Interdisciplinary Environmental Clinic

Re: 2015 Monitoring Network Plan

Re: Comments on Ameren Missouri's Labadie Sulfur Reduction Project Quality Assurance Project Plan

Re: Comments on Ameren Missouri's Analysis of SO₂ and Meteorological Monitoring Stations Around Its Rush Island Energy Center

Figure 1. Modeled peak concentration areas near Ameren's Labadie plant.

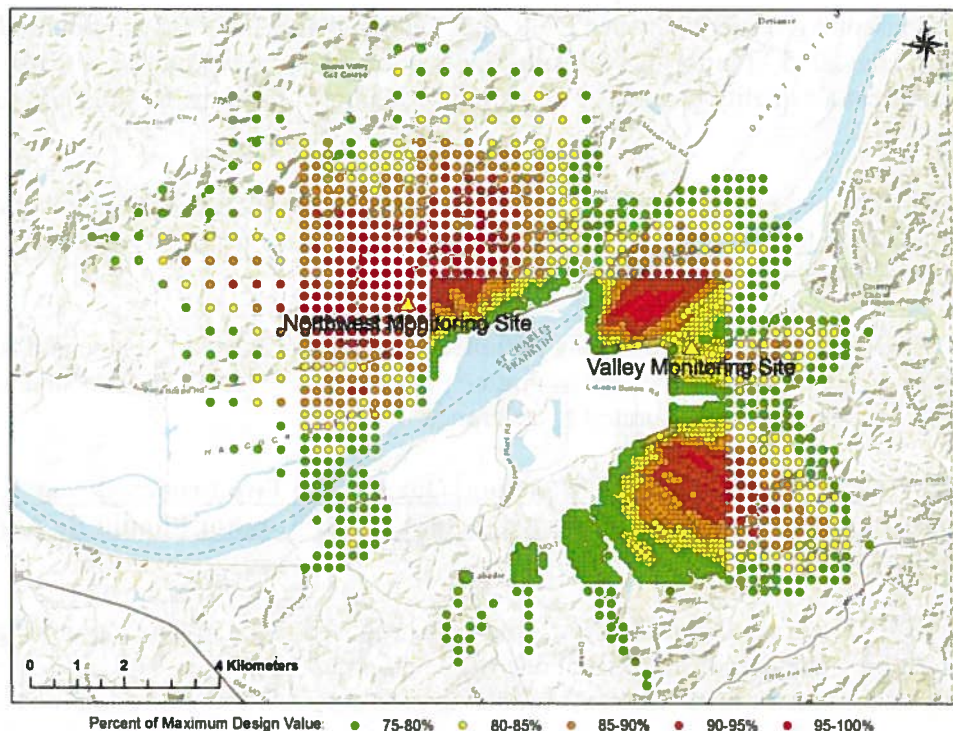
In our April 13, 2015 comments to DNR on Ameren’s proposed new Labadie monitoring sites, attached as Exhibit 1, we demonstrated that one of the proposed sites – the Valley site – is not located in any of the areas where Ameren’s modeling predicts peak SO₂ concentrations are expected to occur. Ameren’s modeling identified three distinct areas where the highest SO₂ concentrations are expected to occur and where high concentrations are expected to occur most frequently. These areas are located northwest, northeast, and southeast of the plant and are shown in Figure 1 below. However, only one of the two proposed Labadie monitoring sites – the Northwest site – is located in one of these peak concentration areas (the one located northwest of the plant). The Valley site is located between the other two peak concentration areas, in an area where the modeled concentration is only about 80 percent of the maximum concentration predicted by the model. As a result, it is unlikely to capture maximum ambient SO₂ concentrations and should be relocated to the peak concentration area northeast of the plant.

In addition, DNR should also require the installation of a third monitor in the peak concentration area southeast of the plant lest anticipated maximum ambient SO₂ concentrations in this area – which are likely to have implications for NAAQS compliance – go undetected by the Labadie SO₂ monitoring network.

Figure 2. DNR model results and polygons drawn around high concentration areas.

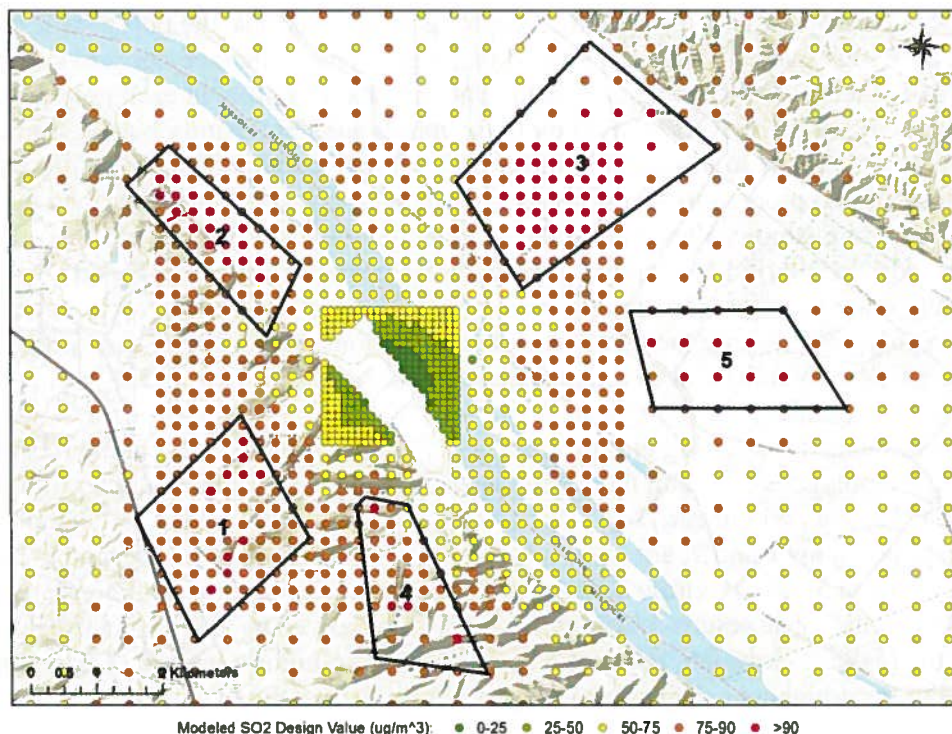
However, DNR's analysis of its modeling is based on a methodology that inherently biases the results. DNR used a telescoping receptor grid in its modeling; specifically, it used a 100-meter receptor spacing out to 1 kilometer, a 250-meter spacing out to 3.5 kilometers, a 500-meter spacing out to 10 kilometers, and a 1,000-meter spacing out to 50 kilometers. In order to identify areas where peak SO₂ concentrations are expected to occur, it plotted the predicted SO₂ design value at each receptor and drew polygons around high concentration areas by including all receptors with concentrations greater than 90 ug/m³. This is shown in Figure 2 below. DNR then

However, because DNR used a telescoping receptor grid, and because the polygons it drew to indicate areas of high concentration are located in a region where the receptor grid spacing varies from 250 to 500 meters, DNR's counts of high concentration receptors in each polygon and its subsequent ranking of the polygons based on those counts are significantly biased. Some of DNR's polygons are likely to have more high concentration receptors than others just by virtue of the fact that the receptors in those polygons are spaced more closely together than they are in other polygons. For example, almost all of the receptors in polygons 1 and 2 are spaced 250 meters apart, whereas all of the receptors in polygon 5 are spaced 500 meters apart. As a result there are many more receptors – including more high concentration receptors – in polygons 1 and 2 than in polygon 5 despite the fact that all three polygons are similar in size (polygon 5 is slightly larger than polygon 2 and slightly smaller than polygon 1).

One way to eliminate the counting bias resulting from DNR's use of a telescoping receptor grid is by ranking the polygons based on the percentage instead of the absolute number of high concentration receptors within each one. This effectively adjusts for the fact that certain polygons, e.g., polygons 1 and 2, are likely to have more high concentration receptors than others, e.g., polygon 5, just by virtue of the fact that the receptors in those polygons are spaced more closely together. The results of this analysis are summarized in Table 2 below. Polygon 3 is still ranked the highest. However, polygon 5 is ranked second-highest instead of polygon 2, which drops to third-highest – displacing polygon 1 from the top three.

Figure 3. DNR model results for uniform 250-meter receptor grid.

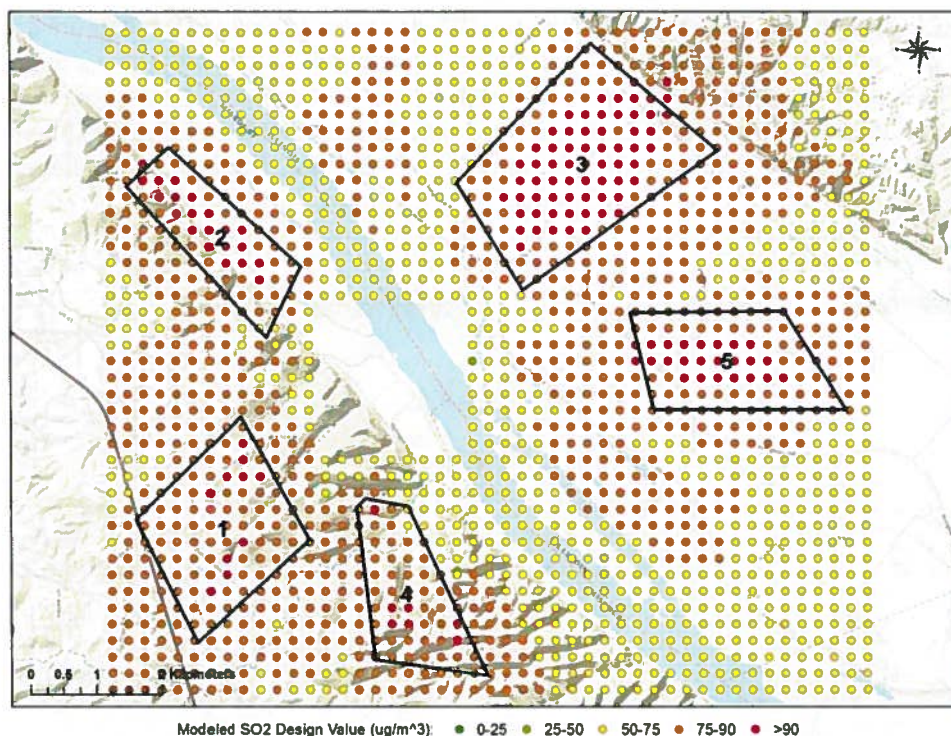
A better way to eliminate the counting bias resulting from DNR's use of a telescoping receptor grid is to replace the telescoping grid with a uniform grid so the receptor spacing is the same in all five polygons. To determine how this would affect receptor counts and polygon ranks, we re-ran DNR's model using a uniform 250-meter receptor spacing and analyzed the results using DNR's methodology. The results are shown in Figure 3 below, and the number of high concentration receptors in each polygon and the ranking of polygons from highest to lowest in terms of the number of high concentration receptors they contain are summarized in Table 3 below. We also ranked the polygons based on the percentage instead of the absolute number of

When modeled with a uniform receptor grid, the three highest ranking polygons – both in terms of the number and percentage of high concentration receptors they contain – are 2, 3 and 5, **not** 1, 2 and 3 as DNR's flawed analysis concluded. These are the areas predicted to have the highest modeled impacts and thus where SO₂ monitoring sites should be located. An analysis of the top 10, 25, and 50 receptors supports this conclusion. All but one of the top 10 receptors are located within polygon 3, all but one of the top 25 receptors are located within polygons 2 and 3, and all but one of the top 50 receptors are located within polygons 2, 3 and 5. This is shown in Figure 4 below, which includes a filled contour plot of modeled design values that clearly shows how much larger the peak concentration areas are in polygons 2, 3 and 5 compared to the other polygons.

Figure 5. Ameren's proposed SO₂ monitoring sites relative to DNR's polygons. Peak concentration areas (>90 ug/m³) are shaded red.

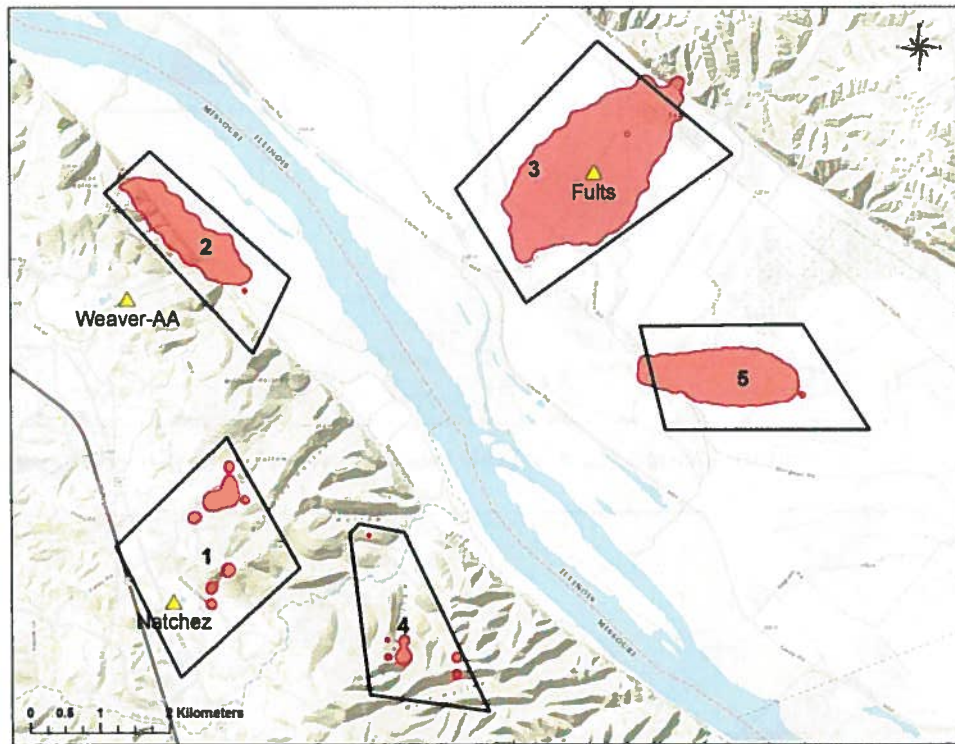
The locations of Ameren's proposed SO₂ monitoring sites – dubbed Fults, Natchez and Weaver-AA – relative to DNR's polygons are shown in Figure 5 below. Of the three proposed sites, only the Fults site, which is inside the peak concentration area within polygon 3, is properly located. The Weaver-AA site, which Figure 2 of Monitoring Network Plan Appendix 5 incorrectly shows being within polygon 2, is actually located outside of it based on the site coordinates provided in Plan Appendix 1. Hence it is not properly located. Nor is the Natchez site, which should be located within polygon 5 instead of polygon 1 because polygon 5 has higher modeled impacts.

Because they are not properly located, neither the Natchez nor Weaver-AA monitoring sites will adequately represent Rush Island's SO₂ air quality impact. Therefore, both sites should be relocated. The Weaver-AA site should be located inside the peak concentration area within polygon 2 and the Natchez site should be located inside the peak concentration area within polygon 5 as shown in Figure 6 below. Alternatively, the Natchez site could be moved inside the peak concentration area within polygon 1 and a fourth monitor added inside the peak concentration area within polygon 5 as shown in Figure 7 below. The recommended monitor locations shown in Figures 6 and 7 are easily accessible and appear to meet EPA siting criteria and have ready access to power.

Figure 1. Receptors with modeled design values ≥ 75 percent of the maximum design value.

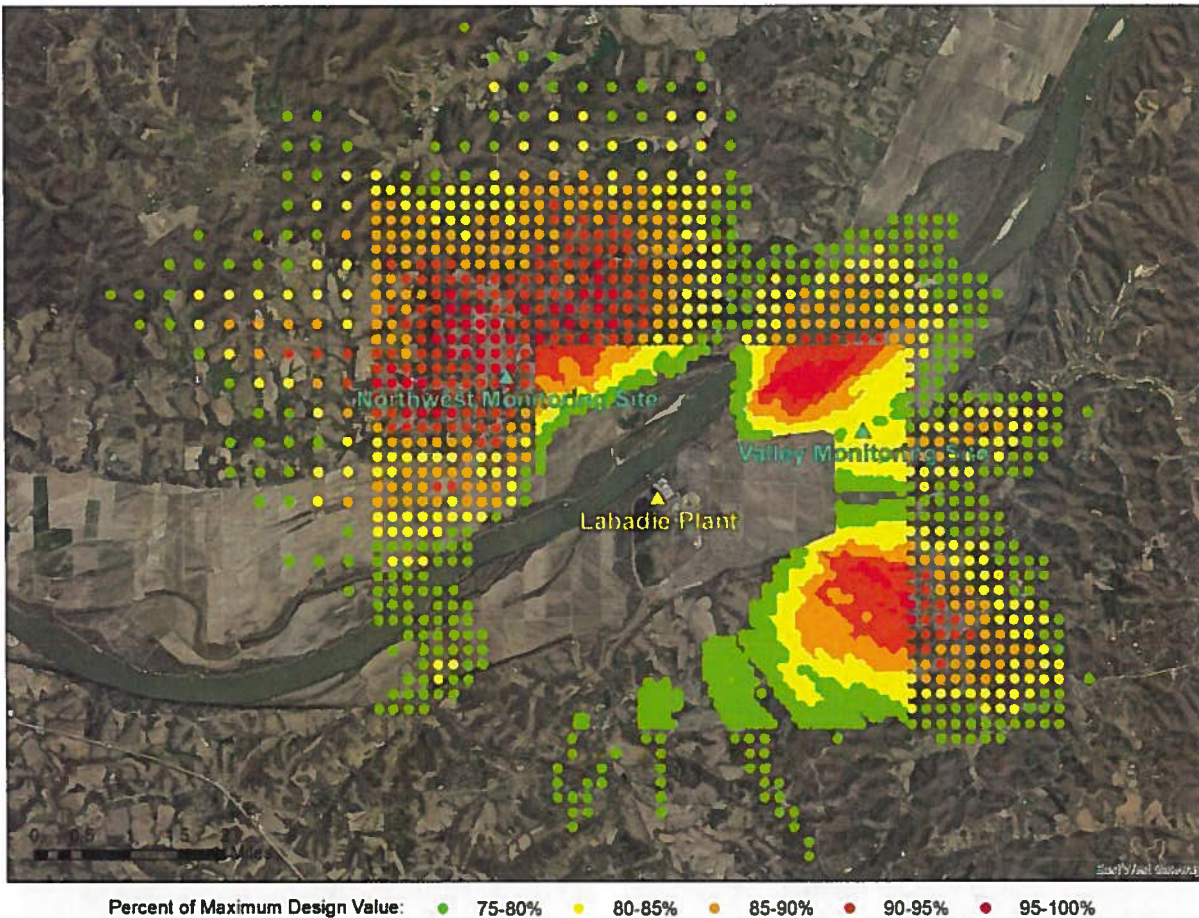
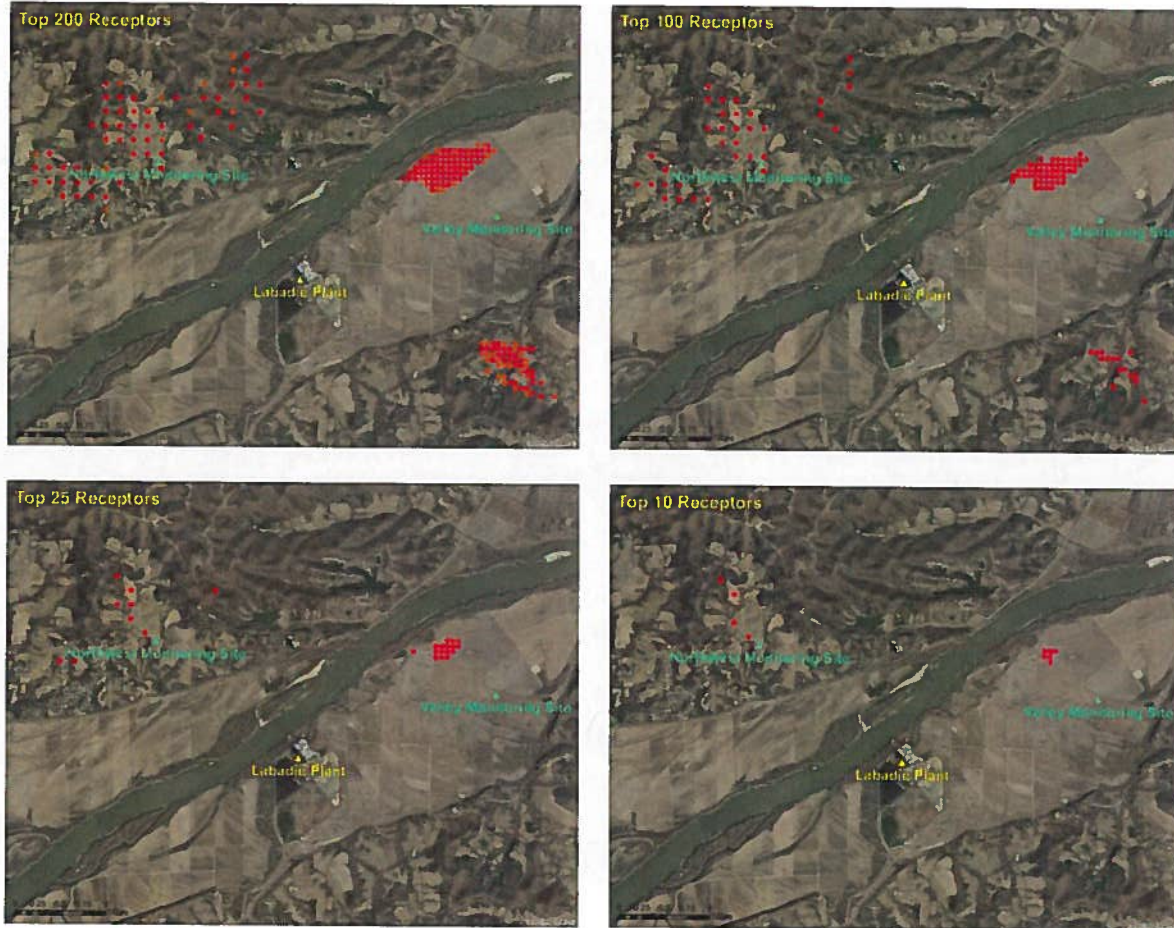
Figures 1 and 2 reveal three distinct areas where modeled design values are in excess of 95 percent of the maximum modeled design value and where the majority of the top 200 receptors (and all of the top 100, 25 and 10 receptors) lie. These areas, located northwest, northeast, and southeast of the Labadie Energy Center, are where the modeling predicts peak 1-hour SO_2 concentrations are expected to occur. Furthermore, although a rigorous comparison is not possible without detailed receptor data, a simple visual comparison of Figures 1 and 3 indicates that the areas where peak 1-hour SO_2 concentrations are expected to occur (i.e., where modeled design values are in excess of 95 percent of the maximum modeled design value) overlap with the areas where daily maximum 1-hour SO_2 concentrations most frequently exceed 75 percent of the maximum modeled design value. Monitoring stations located in these areas would have the greatest chance of identifying peak SO_2 concentrations in ambient air, which is the primary objective of source-oriented monitoring and an absolute necessity when monitoring to assess compliance with the NAAQS.

However, only one of Ameren's proposed monitoring sites, the northwest site, is located in one of the three peak concentration/high frequency areas predicted by the modeling (the one located northwest of the plant). No monitoring sites are proposed in the peak concentration/high frequency areas located northeast or southeast of the plant. Instead, Ameren's only other proposed monitoring site, the valley site, is located in an area where modeled design values are only about 80 percent of the maximum modeled design value and where daily maximum 1-hour SO₂ concentrations exceed 75 percent of the maximum modeled design value about half as often as they do in areas where this occurs with the greatest frequency. This makes the valley site an inappropriate site for a monitor to assess compliance with the NAAQS. Ameren's modeling predicts that ambient SO₂ concentrations will be as much as 25 percent higher in several areas around the plant than they will be at the valley site, meaning a monitoring station at the valley site could be in compliance with the NAAQS while significant violations were occurring nearby.

- 1) Relocate the proposed valley monitoring site to the peak concentration/high frequency area northeast of the plant; and
- 2) Add a third monitoring site in the peak concentration/high frequency area southeast of the plant.

Figure 3. Number of maximum daily 1-hour SO₂ concentrations at each receptor that exceed 75 percent of the maximum modeled design value.

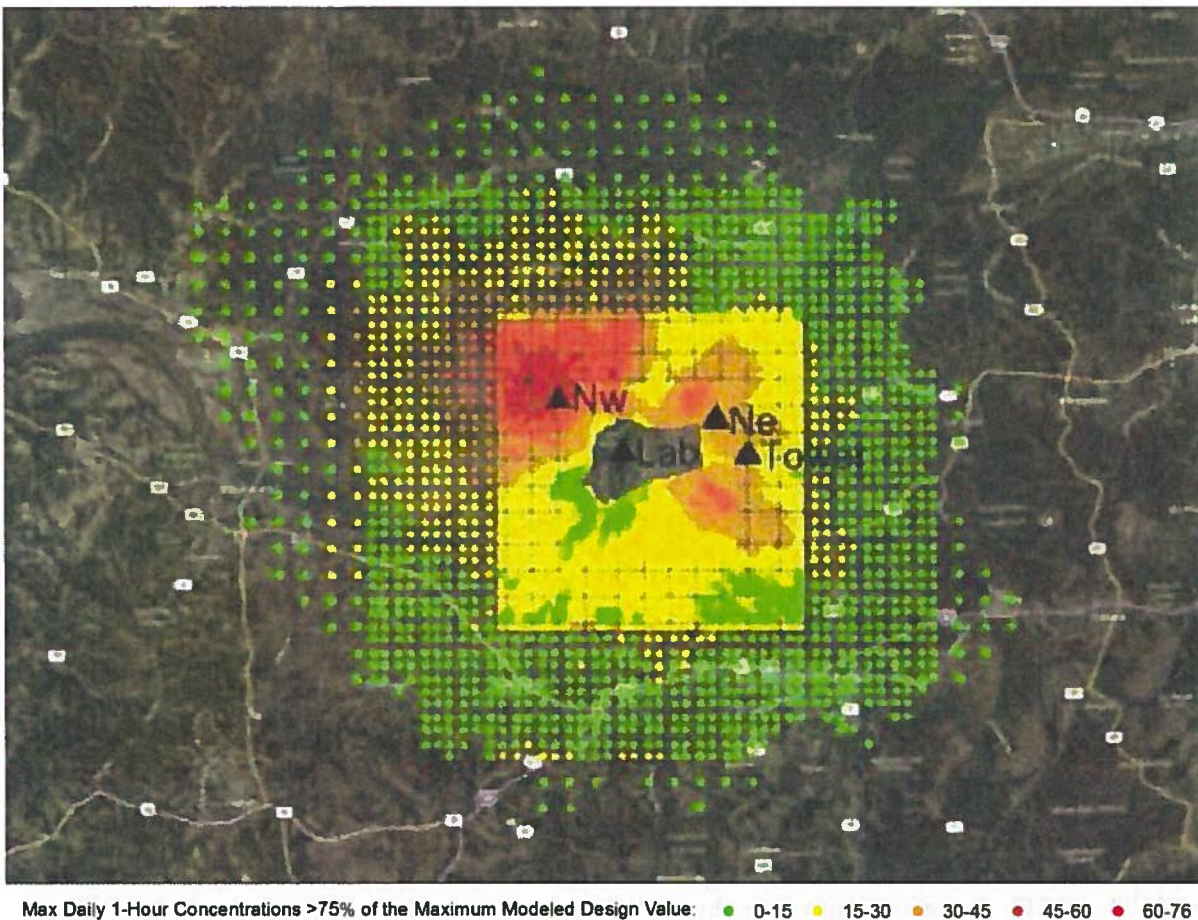
The QAPP states that a monitor could not be sited in the peak concentration/high frequency area northeast of the plant because it is an actively farmed area, physical access is almost impossible

without building additional infrastructure, and electric power is not available. These justifications do not stand up to the barest scrutiny. The entire Labadie Bottoms is an actively farmed area, accessible only by unimproved roads that severely limit vehicular access during wet weather conditions. As such, the proposed valley monitoring site is no more accessible than a site within the peak concentration/high frequency area northeast of the plant would be, and additional road infrastructure will likely be necessary for all-weather access regardless of where in the Labadie Bottoms the monitor is located.⁴ Furthermore, electric power is not available anywhere within the Labadie Bottoms, including at the proposed valley monitoring site. Therefore, distribution infrastructure will have to be built to deliver power to any monitoring site in the Labadie Bottoms regardless of where it is located. The St. Albans Water and Sewer Authority/Franklin County PWSD #3 wastewater treatment facility, located approximately 1 kilometer east of the proposed valley monitoring site, appears to be the closest available source of electric power for monitoring sites in the Labadie Bottoms, and only a minimal amount of additional line would be necessary to deliver power to a monitor located in the peak concentration/high frequency area northeast of the plant compared to one located at the proposed valley monitoring site.

The QAPP's justification for not siting a monitor in the peak concentration/high frequency area southeast of the plant is equally flimsy. The QAPP states that the primary reason a monitor is not proposed in that area – despite the model predicting high design values and a high number of daily maximum 1-hour SO₂ concentrations in excess of 75 percent of the maximum modeled design value in that area – is because the elevated terrain there is similar to the terrain at the proposed northwest monitoring site and it was believed an additional elevated terrain site was not necessary. However, AERMOD accounts for terrain influences when calculating modeled design values, and variations in meteorological parameters, most notably wind direction, often result in peak 1-hour SO₂ concentrations occurring in different areas that have similar terrain (e.g., areas in different cardinal directions from the source). Therefore, the peak concentration/high frequency area southeast of the plant cannot be ignored simply because the terrain there is similar to the terrain in the peak concentration/high frequency area northwest of the plant. The purpose of an ambient SO₂ monitoring network is not to monitor different terrain types, but to monitor areas where peak 1-hour SO₂ concentrations are expected to occur regardless of the terrain in those areas. The QAPP also suggests that the high concentrations and frequencies predicted by the model southeast of plant are merely an artifact of the Jefferson City, MO Airport meteorology, which is influenced by the local orientation of the Missouri River valley at that met station. However, the wind roses provided in the QAPP for a number of met stations in eastern Missouri that are closer to Labadie, which the QAPP states better reflect the expected meteorology at Labadie, all show significant winds from the north or northwest, which is consistent with an area of peak concentration/high frequency southeast of the plant.
